## Questions and Comments Following PJM Response to Model Comments

PJM's comments from their response, "20190806-pjm-comments-for-pseg-feedback-post-meeting.pdf", are contained in the text boxes with my comments and questions below.

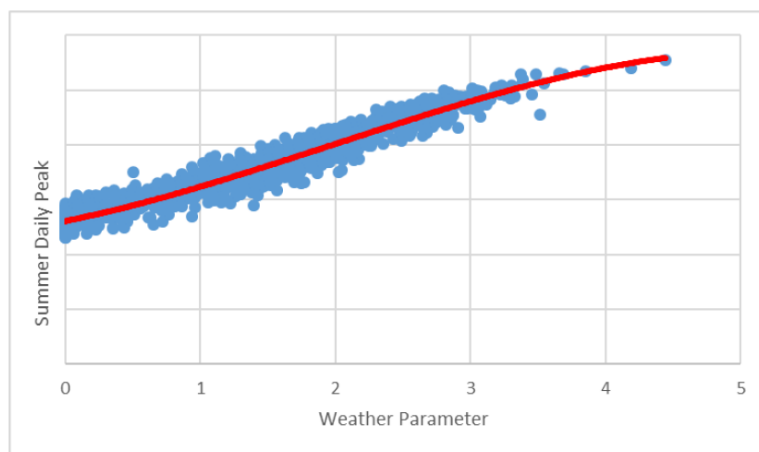
I was not reading too much into the shape of the graph. It was explicitly presented by PJM as the justification for the use of the cubic polynomial.

Referencing the graph above, how is this taking into account year-to-year trends and calendar effects?

We don't think it's appropriate to read too much into over- or under-stating based on that graph. The graph is purely a presentation of multiple years of data points versus the weather parameter, thus obscures some of the other factors the model would be taking into account (i.e. year-to-year trends and calendar effects). As for the selection of the cubic polynomial, it was chosen based on visual inspection of the data. Here are two examples:
